TOWN OF HERNDON, VIRGINIA
ARCHITECTURAL REVIEW BOARD PUBLIC HEARING AGENDA
JULY 20, 2022
HERNDON COUNCIL CHAMBERS BUILDING
765 LYNN STREET
7:30 P.M.

Title: ARB #22-013; New signage; 625 Elden Street

Title: ARB #22-015; Sign alteration; 700 A Monroe Street

2.0 Elevation: LED Illum. S/F Monument
Scale: 3/4" = 1'-0"

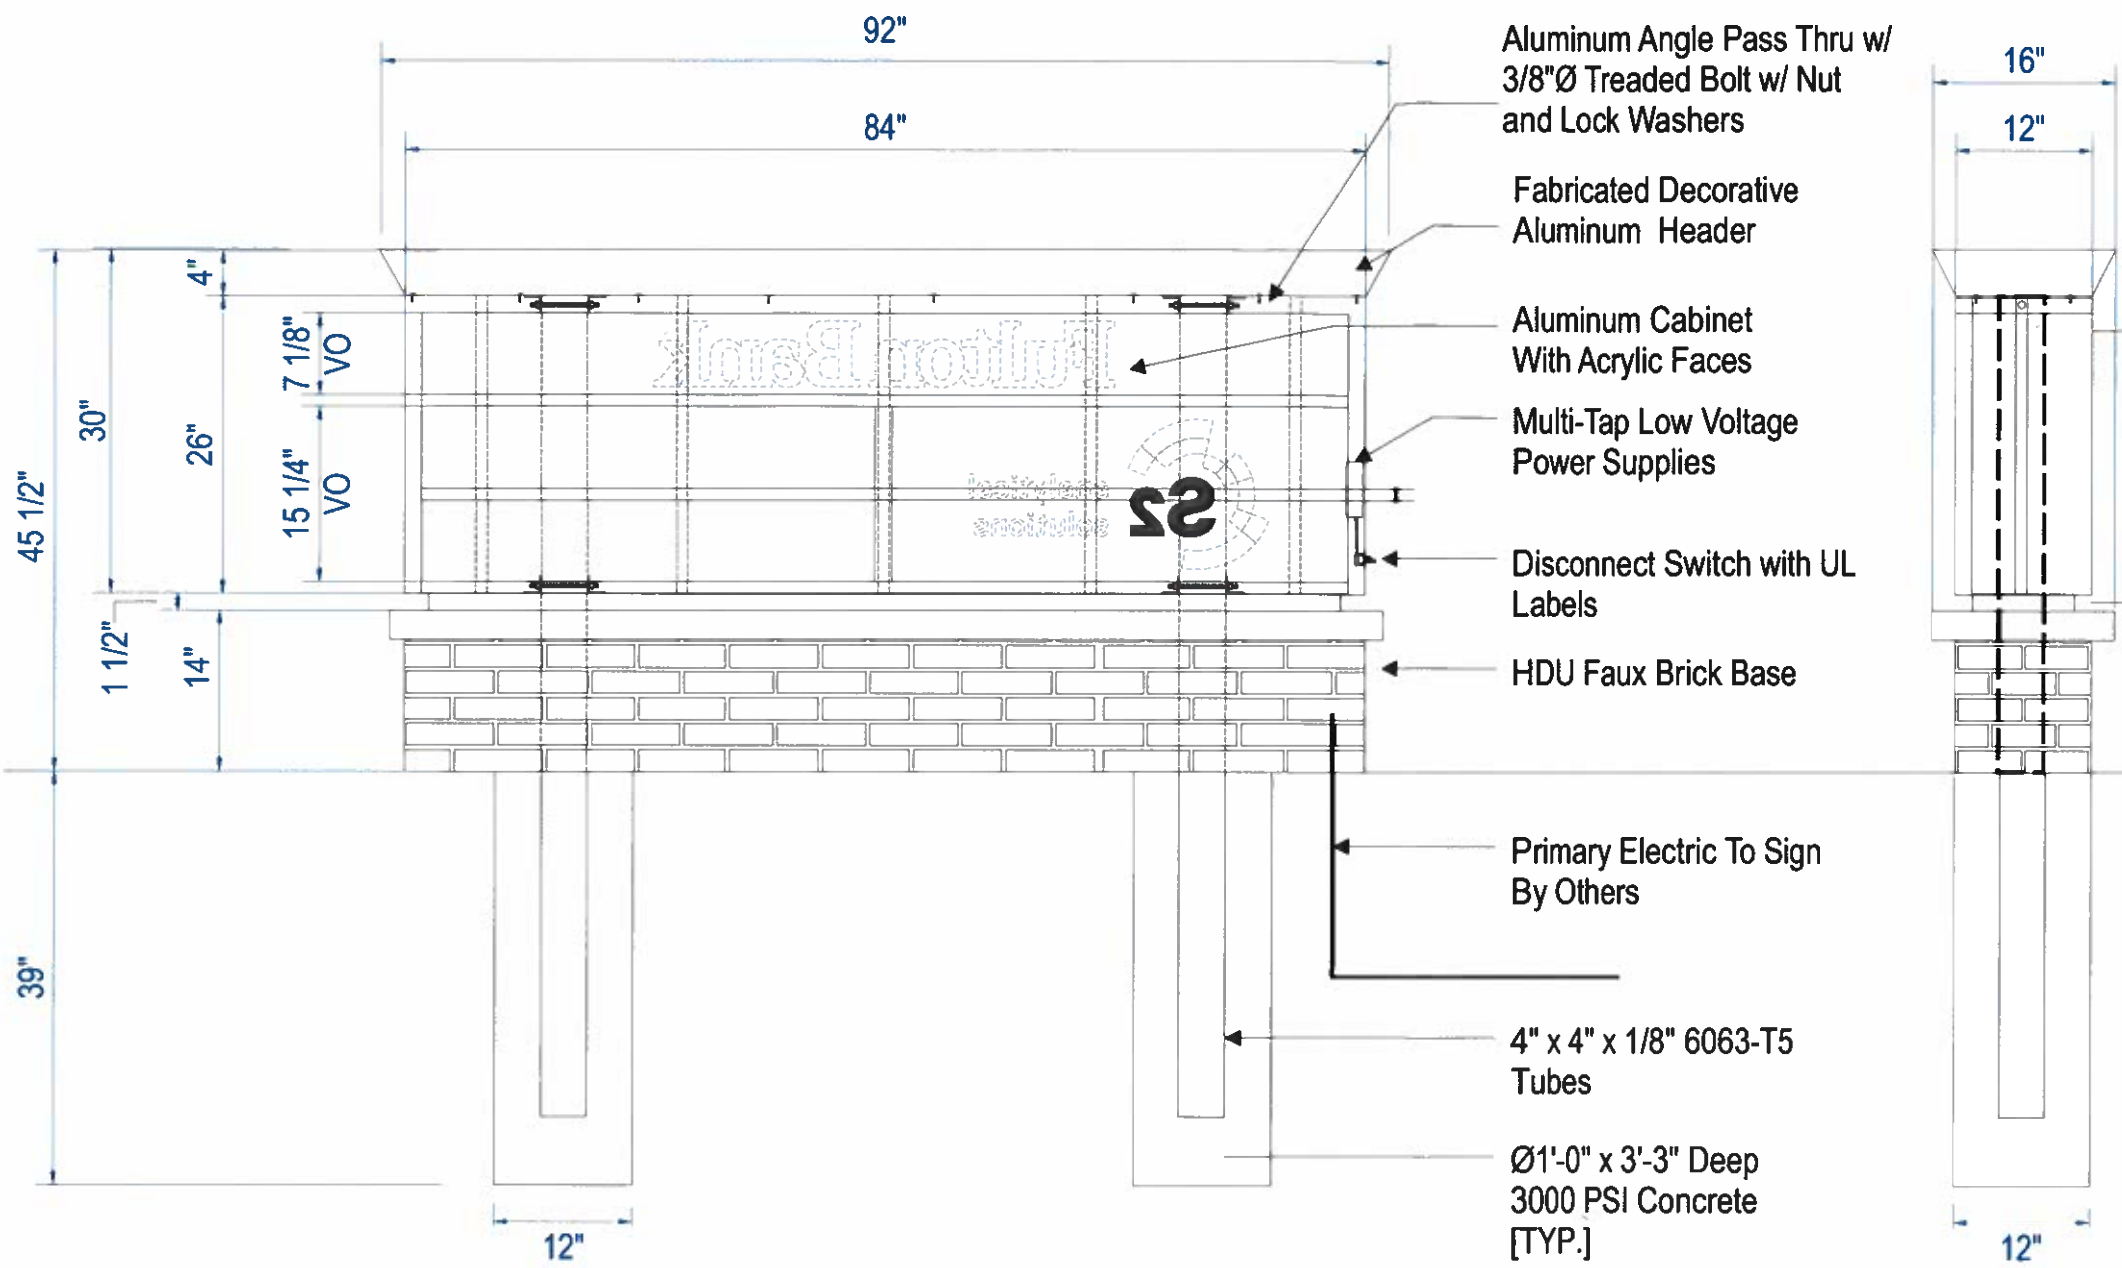
This application is for two business identification signs, one monument sign and one wall sign at 625 Elden Street. The monument sign requires a site plan prior to a review by the board, and therefore is not addressed in this staff report. Following site plan approval, the applicant may re-apply to the board for a review of the monument sign.

- 1) This approval excludes the monument sign portion of this application.

4.0 Elevation: Non-Illum. Pan Sign Qty. = 1
Scale: 1:4

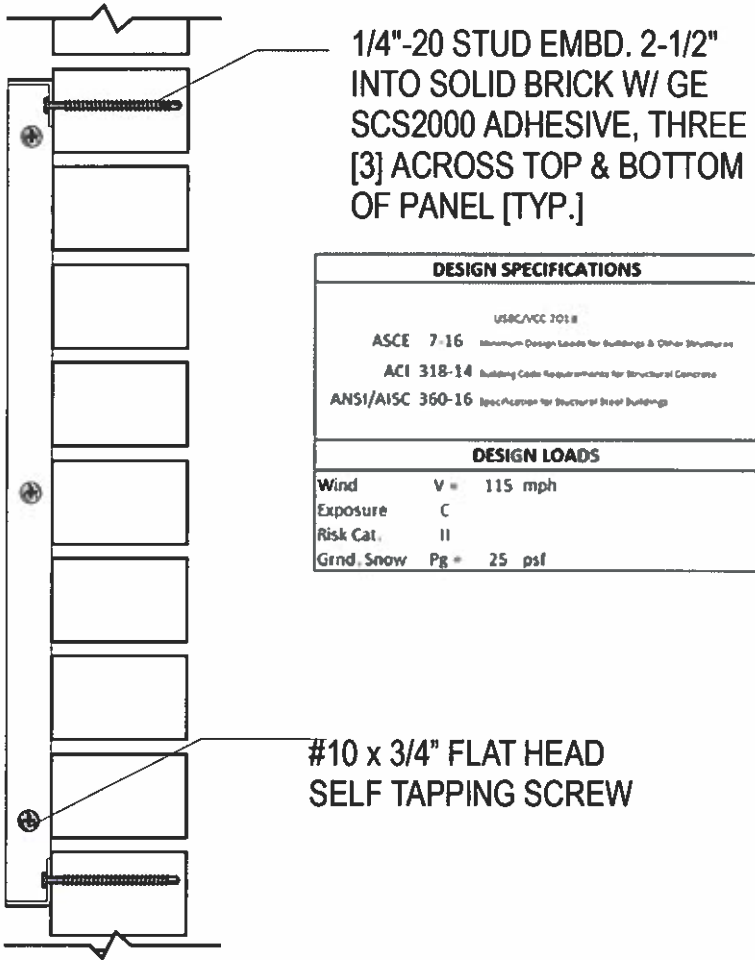
The proposed wall sign may be reviewed by staff, and as such is the subject of this staff report. The sign encompasses 4.5 square feet and has a sign face of non-illuminated painted aluminum with digitally printed vinyl graphics and text. The proposed sign is

flush mounted to the brick façade using aluminum angle clips with masonry anchors. The prospective location of the sign is to the right of the primary entrance to the building. The background of the sign is white and contains a logo and the words “analytical solutions” in red text. The logo and text are digitally printed in vinyl and adhered to the sign face.

- a. The proposed wall sign in its design and construction is suitable for a good suburban community and promotes the use and improvement of the surrounding buildings.

- b. The proposed wall sign clearly and legibly represents the intended business
 - c. The proposed wall sign is compatible with surrounding buildings and architecture. It does not detract from or overshadow the primary structure.

- d. The proposed wall sign is constructed in a way to remain in good condition and withstand normal weather and climate conditions without deteriorating.

RENDERING

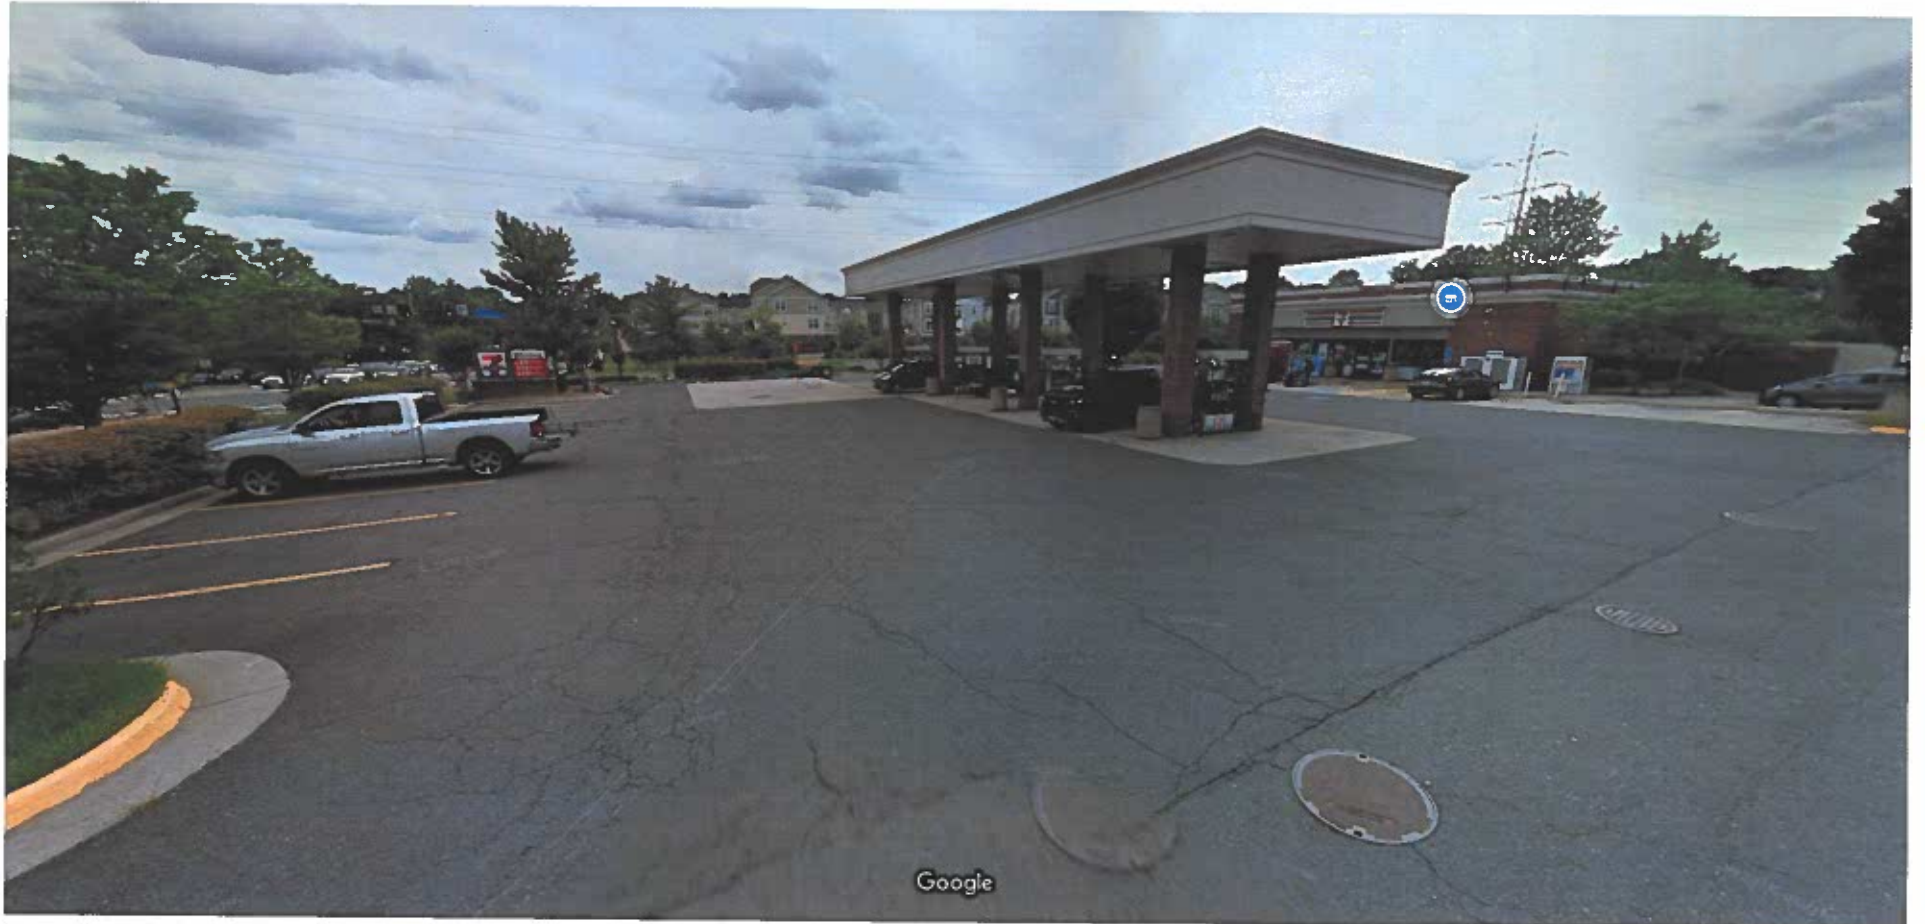
This application is for alterations to an existing monument sign at 700 A Monroe Street. The existing monument sign has a brick masonry base topped with cabinet sign. The sign is divided into two sections, the left portion displaying the branding for 7 Eleven, and the right portion listing gas prices. This application proposes replacing the right-hand portion of the sign which displays gas prices with a digital price display.

1. Staff has found that the proposed signage meets the applicable standards and requirements of the Town of Herndon Zoning Ordinance. The Zoning Ordinance prohibits the use of digital signs for animated, flashing, or frequently changing content. This sign, as proposed, changes infrequently and is generally static.
2. With the findings expressed below, staff believes the proposed signage generally complies with the applicable design criteria within the Town's Architectural Control District, as specified in Section 58-96 of the Town Code of Ordinances.
 - a. The proposed sign alteration does not detract from the existing sign or its integration with the surrounding buildings. It is harmonious in materials, color, and aesthetic.

- b. The proposed sign alteration promotes the surrounding suburban community by updating and modernizing the sign and area.
- c. The proposed sign alteration would be constructed in a way so as to not deteriorate quickly but withstand reasonable weathering.

Approves ARB #22-015, for signage located at 700 A Monroe Street, Herndon, VA in substantial conformance with the design shown in the case materials reviewed by the ARB.
